**FLOOD RISK ASSESSMENT AND  
SURFACE WATER DRAINAGE STRATEGY ADDENDUM**  
St Michaels Convent, Ham Common

- 1.1 This report has been prepared by Glanville Consultants on behalf of Beechcroft Developments Ltd in support of a planning application for the re-development, for residential purposes, of St Michael's Convent, Ham Common, Richmond.

- 1.2 This report is supplementary to the Flood Risk Assessment and Surface Water Drainage Strategy by Glanville Consultants, report number TR8151310/LMcG/DW/021 Issue 3 dated 1 September 2016.

Drawing No. 8151310/001 Rev P3

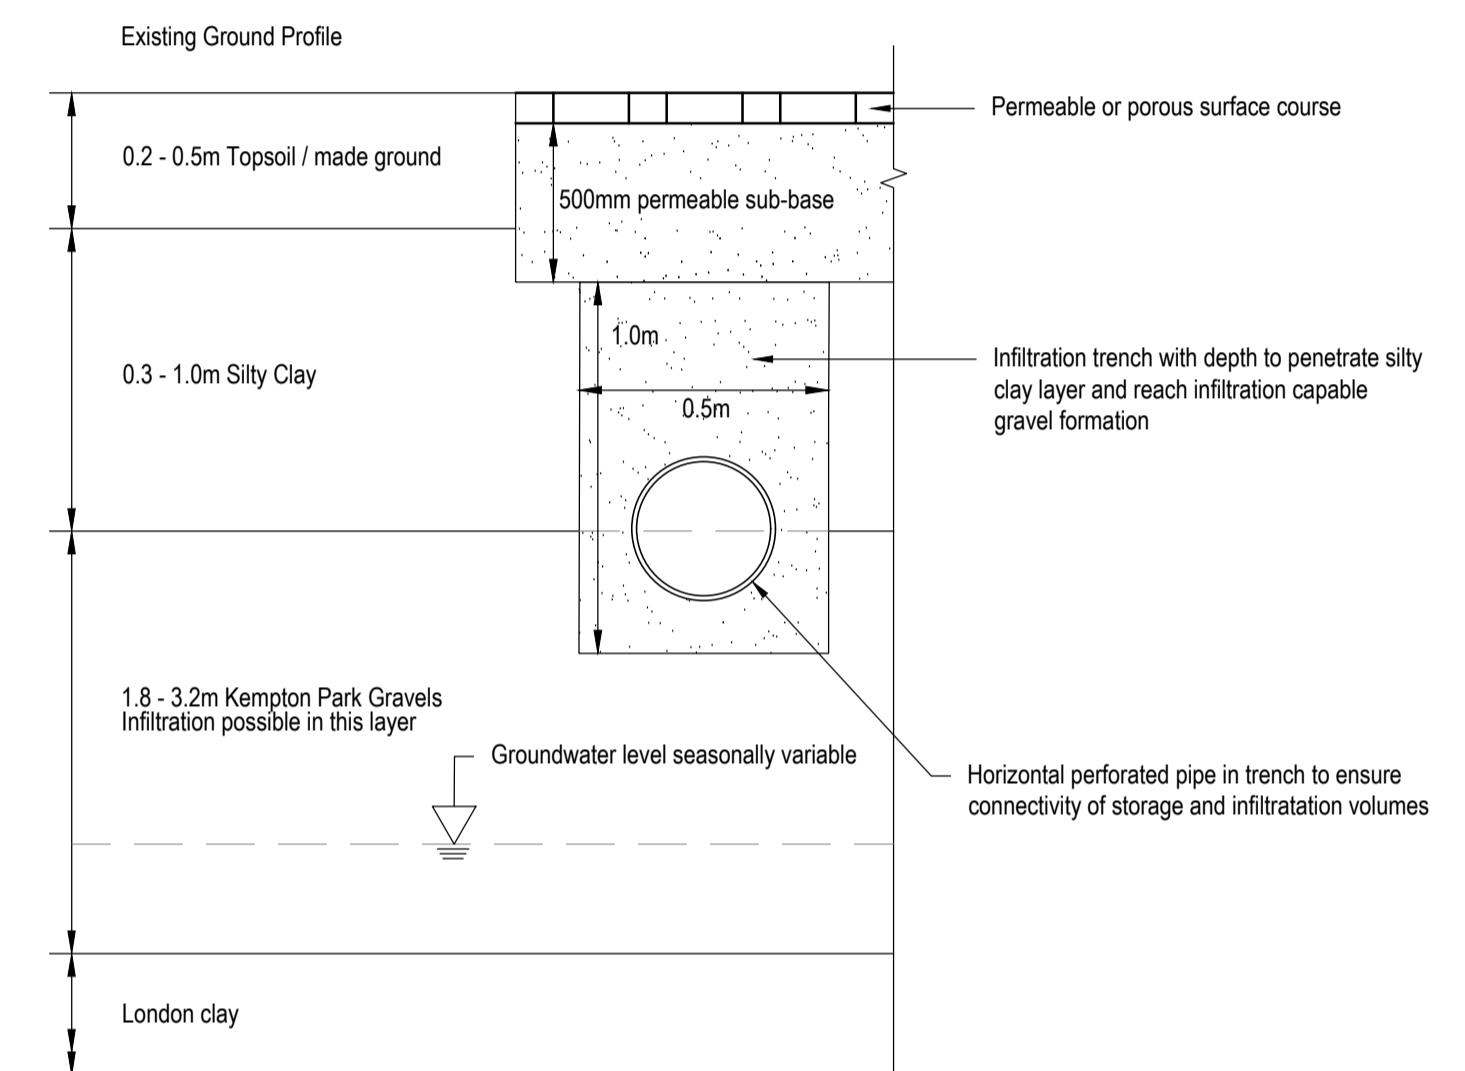
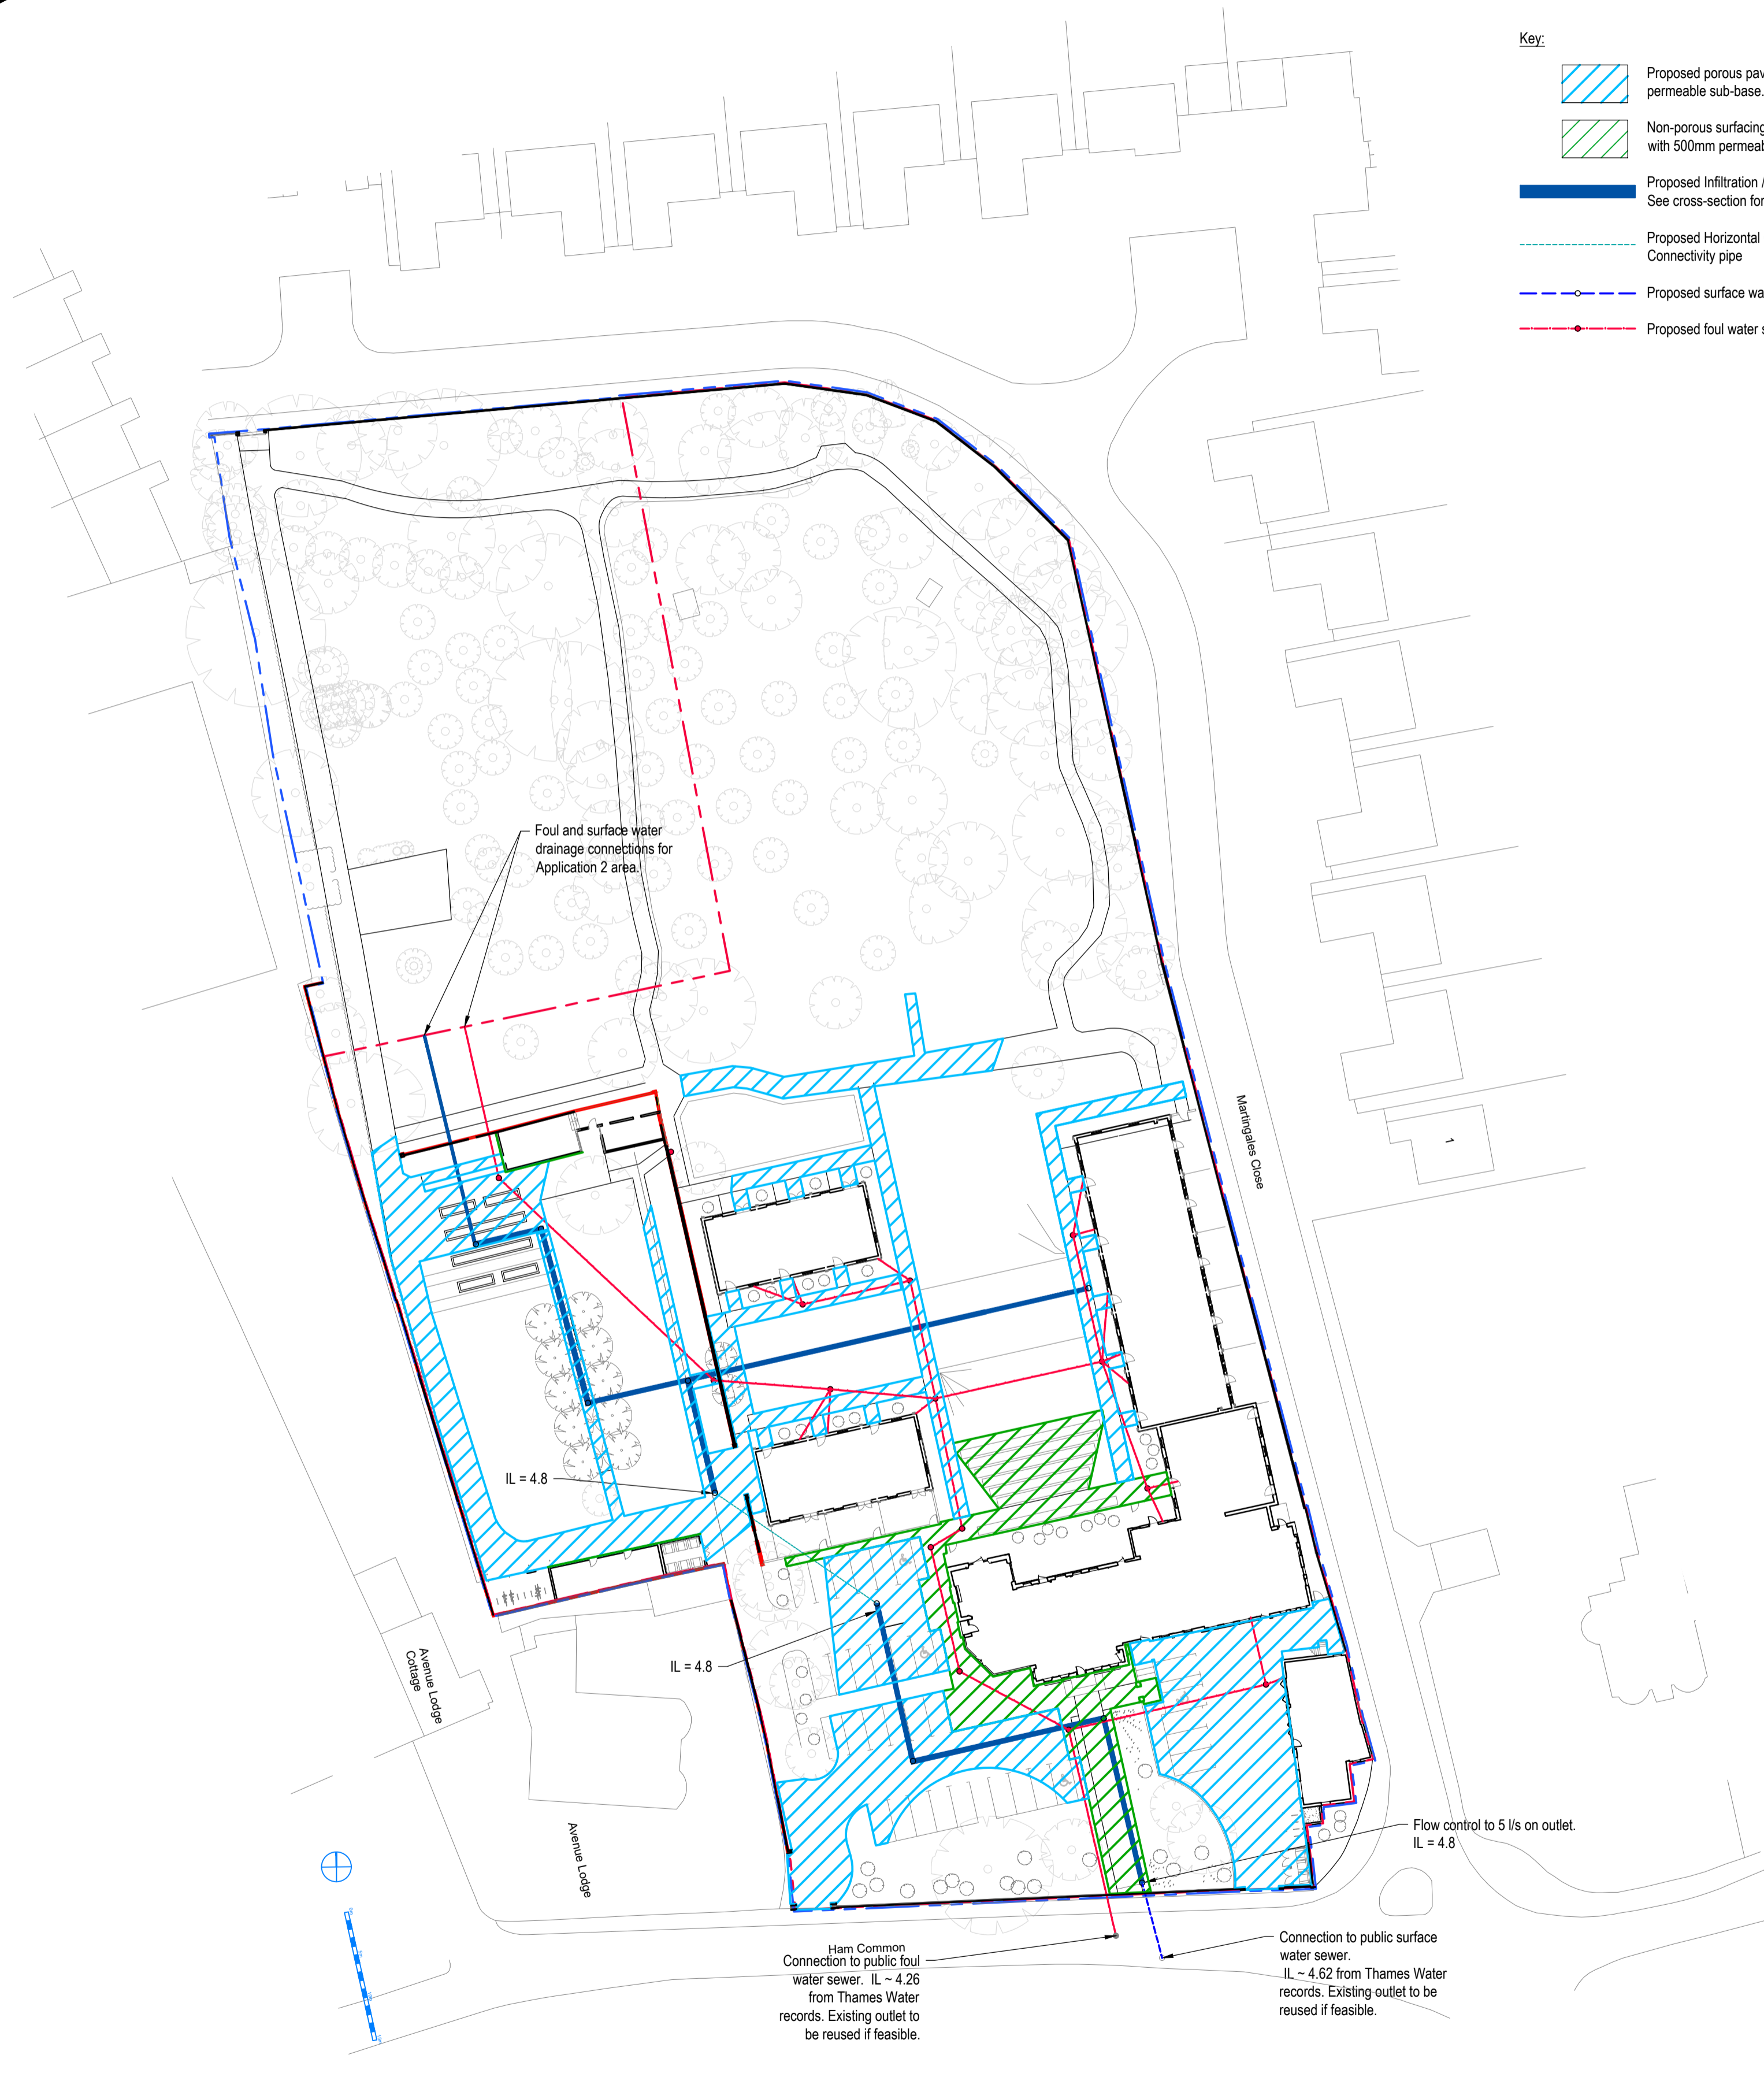
- 3.4 In the revised layout for the first application area, the layout has been drawn closer into the central building. This reduces the amount of impermeable area within the plan, which reduces the impact of the development from the original proposal. The revised impermeable area is measured as approximately 0.442 ha.

- 3.6 Excluding areas within tree root zones, where no deep pavement excavation will be permitted, the usable paving area for sub-base storage within the new site layout is approximately 2450m<sup>2</sup>.

- 3.7 With a sub-base of 500mm depth and a 30% voids ratio, the entire required storage volume can be accommodated within this paved area. Therefore in the revised design there is no requirement for geocellular storage crates to supplement the attenuation provision.

- 3.8 Infiltration trenches will still be included within the design to provide conveyance through the sub-base and encourage infiltration where possible.

- 3.9 A revised drainage strategy plan has been included in Appendix C.
